K.C Bottom & Shirt Wear Company

K. C. Industrial Park, Ratuti, Katchkura, Uttarkhan, Uttara, Dhaka District.
(23.859153N, 90.465239E)
12th February 2017

Observation

**Loose bracings and existence of gap
at connections.**

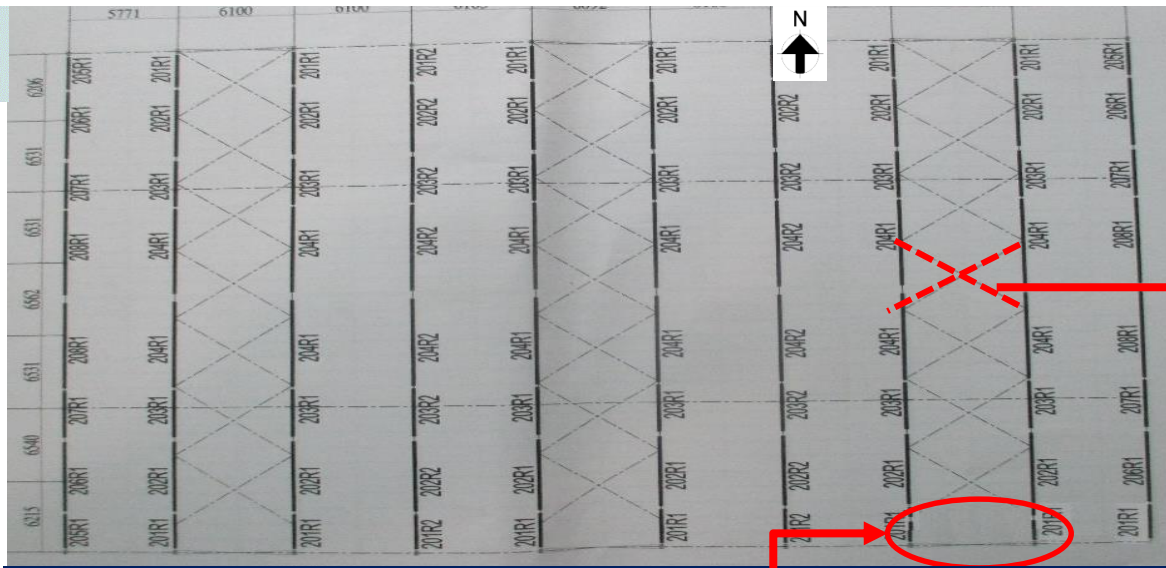
Gap at rafter & column connection

Loose vertical bracings

Gap at rafter & column connections observed throughout the shed. The vertical bracings also appeared to be loosely installed. Factory to tighten the loose connections and vertical bracings according to the suggestion given by the factory engineer.

loose and missing bracings

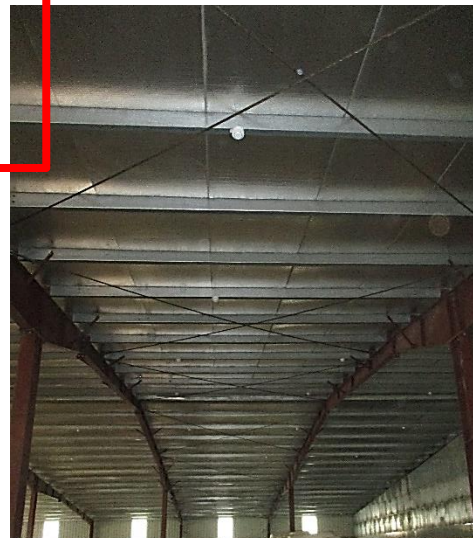
Untied bracings

Sag in horizontal bracing

Vertical bracing are missing in highlighted area and some of the horizontal bracings are appeared to be loosely installed. Sagging of bracings was also observed in the horizontal bracing. Factory to install missing bracing and tighten all loose bracing according to the suggestion by the factory engineer.

Missing bolts

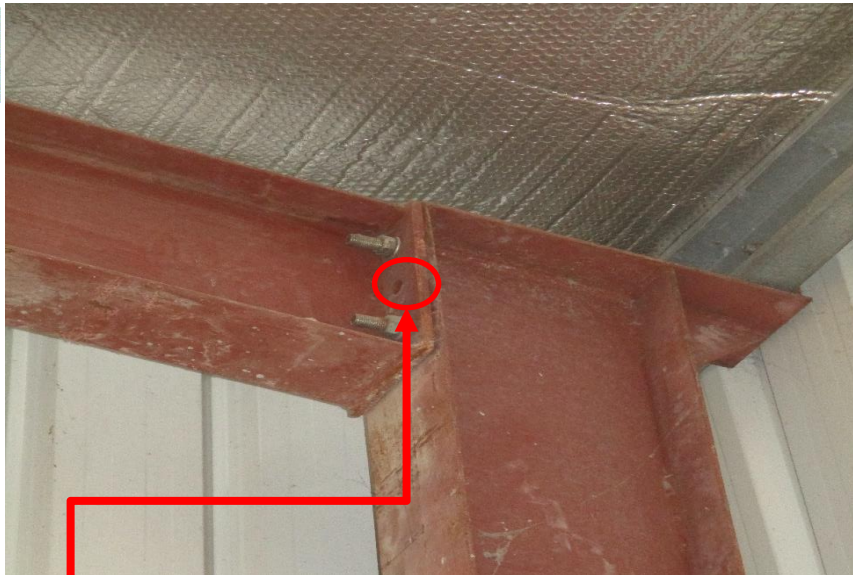
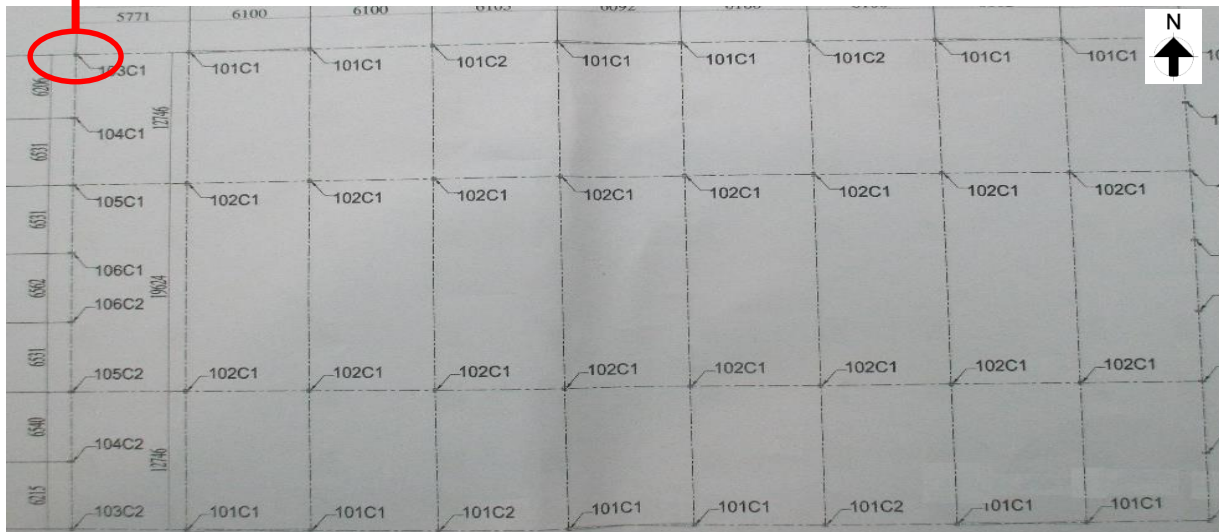
Missing bolt in column-rafter Joint

Missing bolt

Some bolts were missing in rafter joint. Factory to install all missing bolts according to the suggestion given by the factory engineer.

Discrepancy between provided drawing and as constructed condition

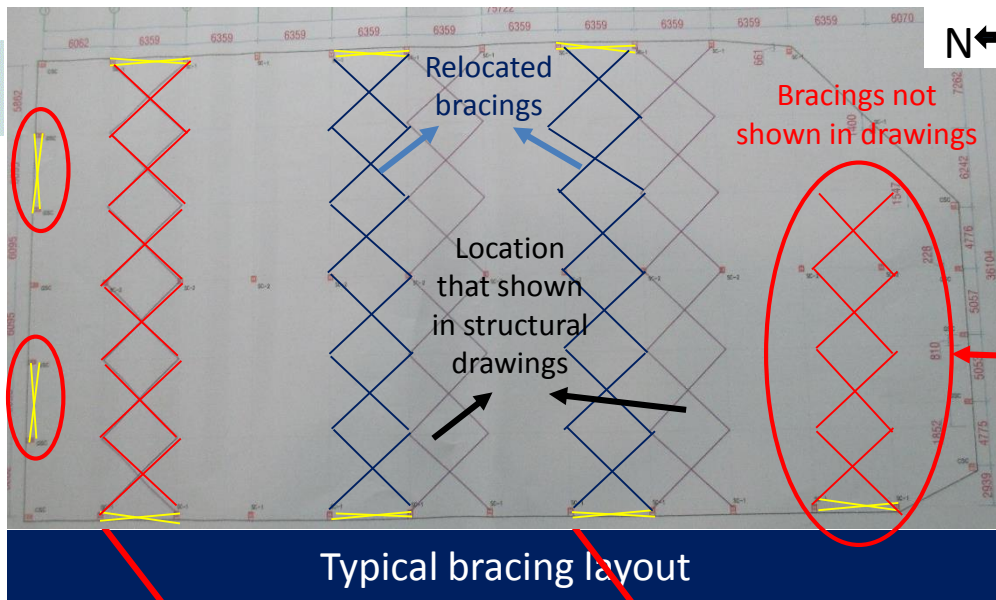
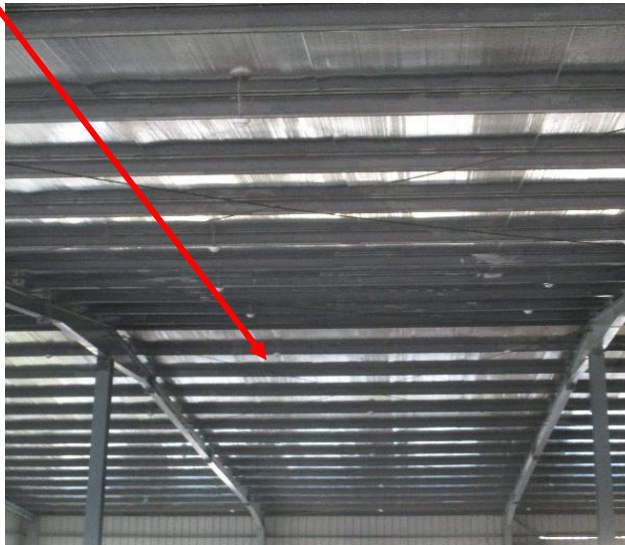
Vertical bracing not shown in drawing

Vertical bracing not shown in drawing

Bracing location are deviated from original layout

Roof bracings at mid portion of the structure were found installed at different location. Red circled bracings were not shown in drawing. Factory engineer to update as-built drawing reflecting as constructed condition and also check the lateral stability of the shed.
